**Accent Housing Ltd**

**Plane Street  
Huddersfield**

**Stage 1 Road Safety Audit**

Report Ref:	11294/AND/001/01	June 2020	
Author:	Adam Darwin		
Checked & Approved:	Simon Burkinshaw	Date:	24 <sup>th</sup> June 2020

***Marked up plan***

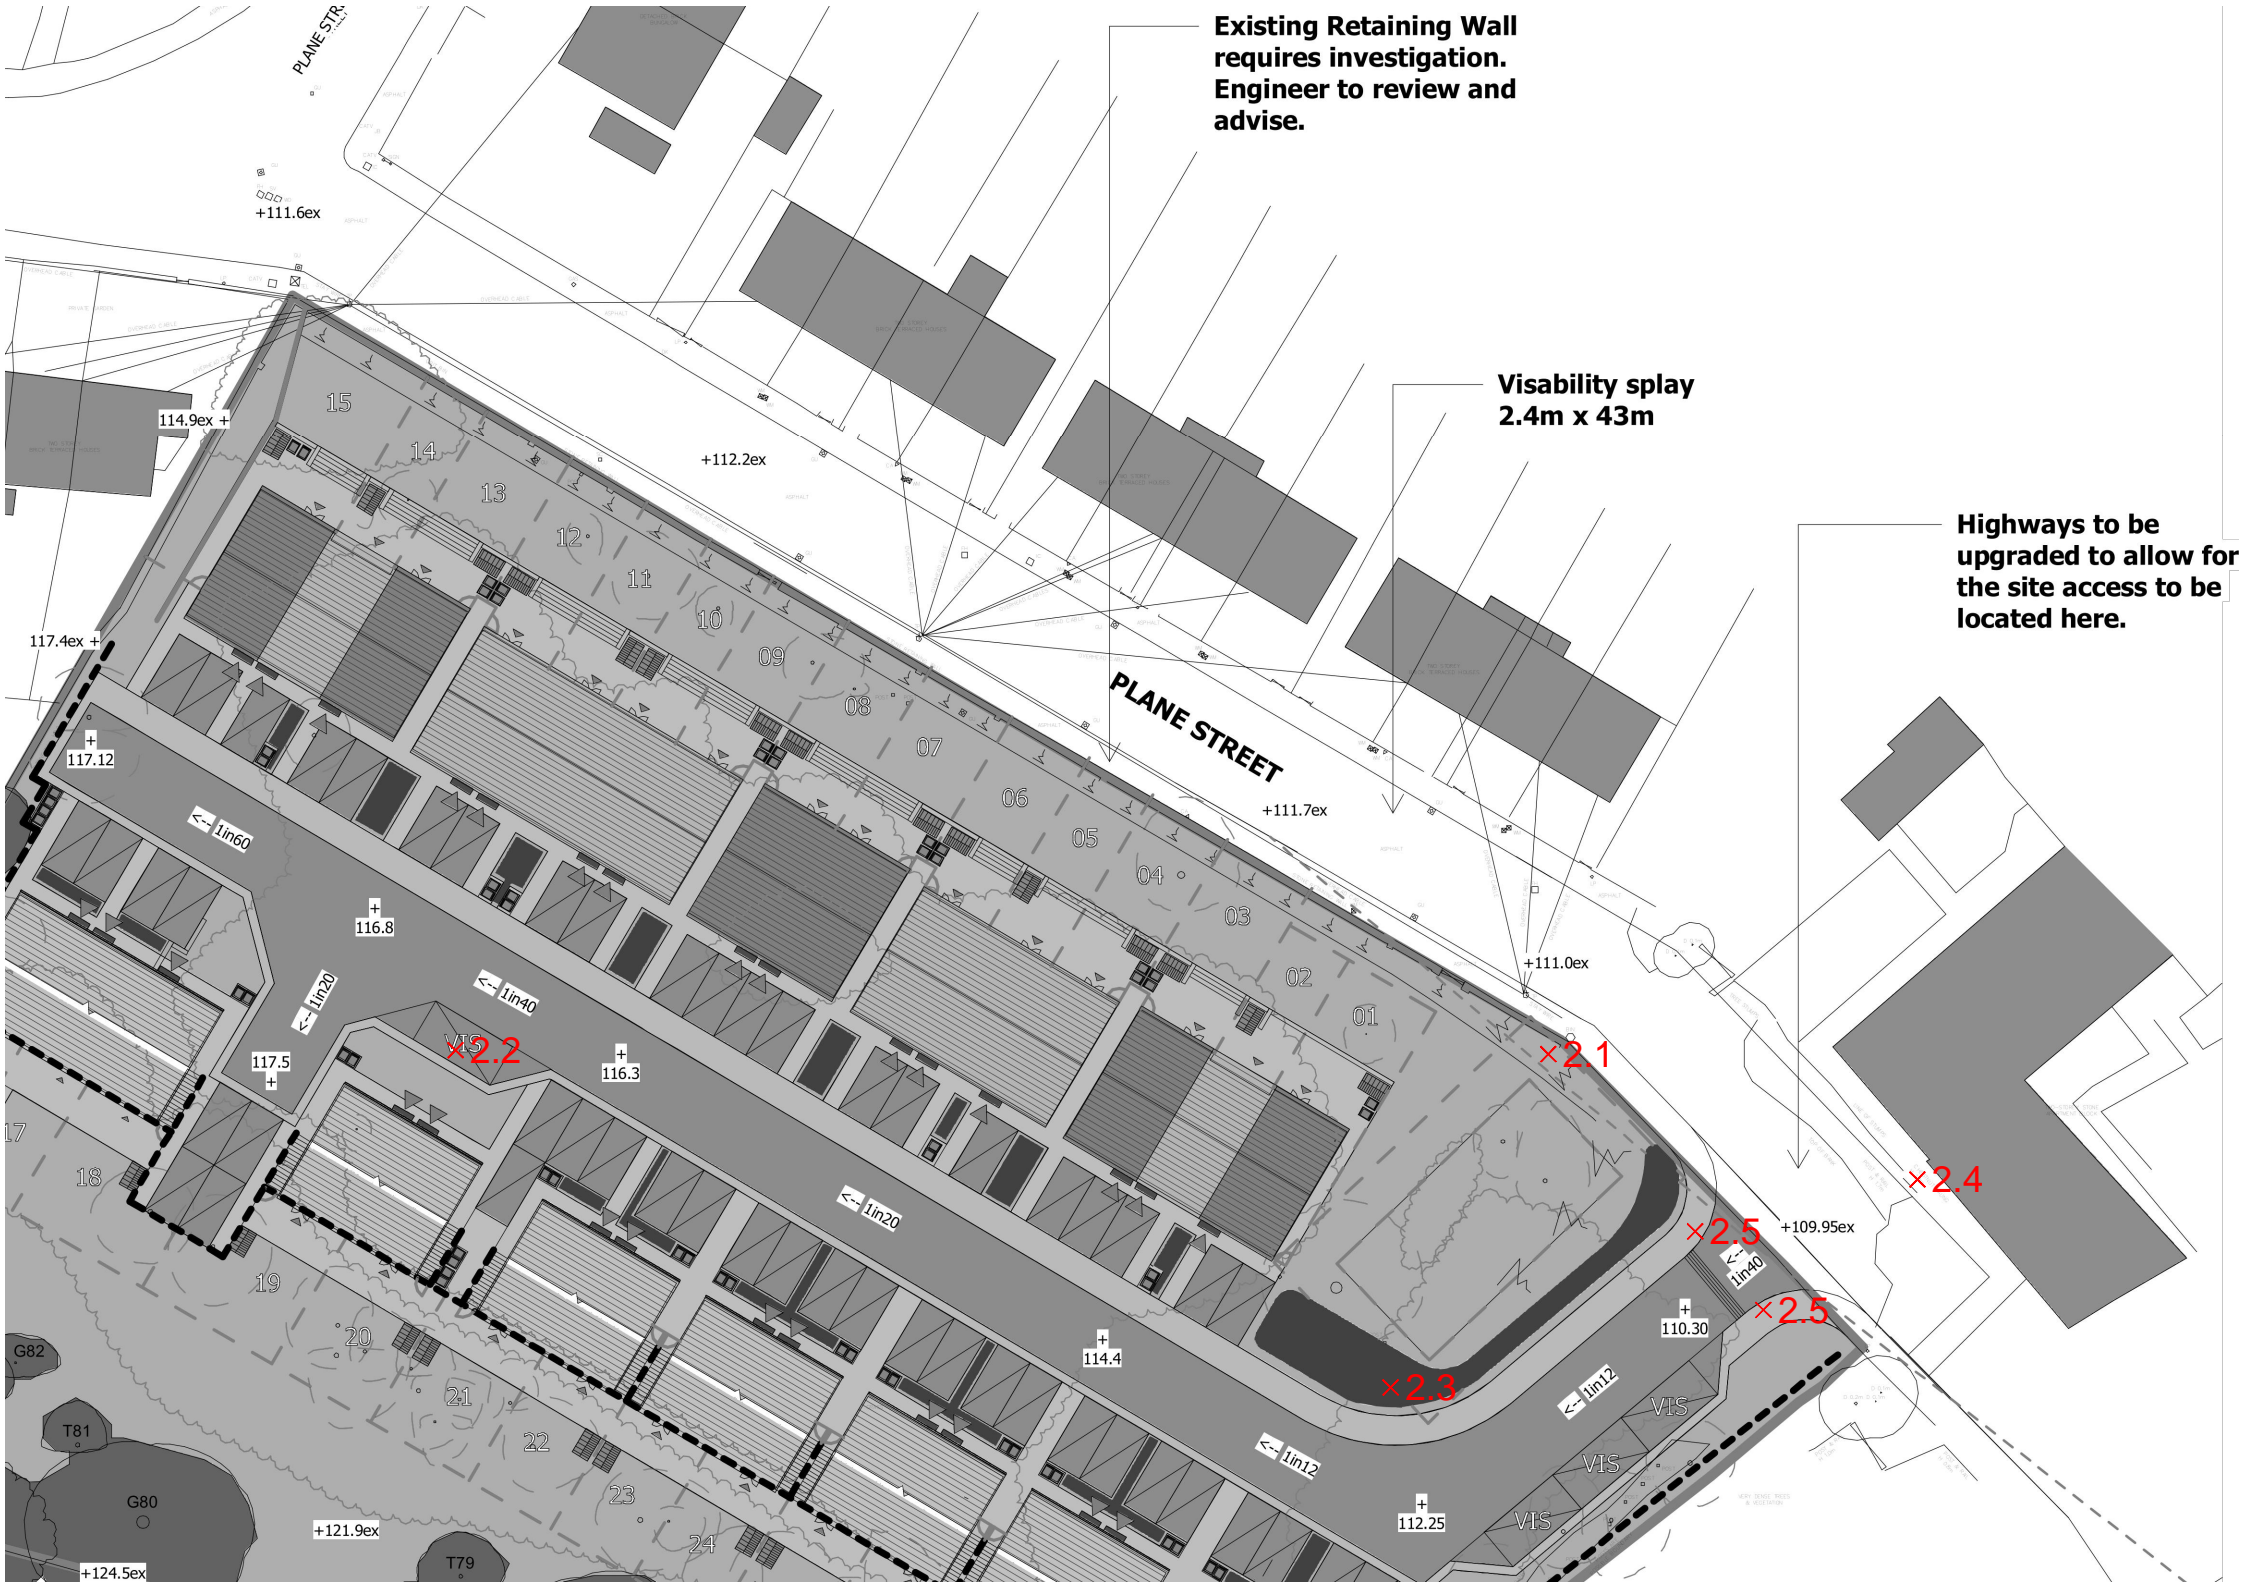
**Summary:** The 2.4x43m visibility splay to the west of the site access is shown passing over the existing site boundary wall. Whilst it is assumed that that the wall will be set back behind the proposed visibility splay, this is not shown on the plans and the ability to do so may be affected by the proposed attenuation tank and easement. Should the wall not be set back, this may restrict visibility at the site access below acceptable minimum levels, which could result in turning type collisions at the junction.

**Summary:** There is only 1 visitor parking space provided towards the western end of the site access road, adjacent to the proposed turning head. As such, visitors or those residents within only 1 parking space may choose to park within the immediate vicinity of the turning head. Should this occur, this could prevent refuse vehicles and other larger vehicles from turning in the highway. This could then result in these large vehicles needing to reverse a long distance around a relatively tight bend and subsequent junction to exit the site, which could result in collisions with other roads users.

**Summary:** There is a relatively tight bend on the site access road, where it would not be possible for a refuse vehicle to pass a car. Whilst this is not necessarily a significant issue on its own due to the low traffic flows that is expected along the road, it is unclear if there will be adequate forward visibility around the bend to allow drivers to give-way before they meet an oncoming vehicle at the bend. As such, this could lead to head on collisions at the bend.

**Summary:** It is proposed to extend Plane Street to the east to allow the new site access to be formed on to it. However, there will be a significant level drop on the north side of this extended section of Plane Street opposite the site access, which would be hazardous to any errant road user. Should an eastbound vehicle travelling towards the site access lose control and leave the carriageway on the north side, there is a risk of a severe incident occurring due to the significant level drop.

**Summary:** No dropped crossing or tactile paving is shown at the site access. The lack of adequate pedestrian crossing facilities at the site access could result in blind/partially sighted pedestrians being struck by turning traffic at the junction.

**Recommendation:** It is recommended that the site access visibility splays are kept clear of any significant vertical obstructions, including walls and larger street furniture (e.g. the existing waste bin).

**Recommendation:** It is recommended that additional visitor parking spaces are provided towards the western end of the site access road, which appears possible by amending the single visitor parking bay in front of No. 19-20.

It is also recommended that the swept path analysis is undertaken to confirm that refuse vehicles can turn at the extended end of Plane Street next to the site access junction, in the event that the access road still becomes blocked and this area is required to allow a refuse vehicle to turn without reversing all the way back to Malvern Rise.

**Recommendation:** It is recommended that adequate forward visibility is provided at the bend that allows drivers to observe an oncoming vehicle; and then wait as necessary before the bend to allow the oncoming vehicle to pass.

**Recommendation:** It is recommended that restraint measures are incorporated on the northeast end of Plane Street to protect all road users from this hazard.

**Recommendation:** Pedestrian crossing facilities and associated tactile paving should be provided across the site access. These crossing facilities should be located such that adequate visibility is provided, to allow pedestrians to see and be seen passed the visitor parking bays on the site access road.
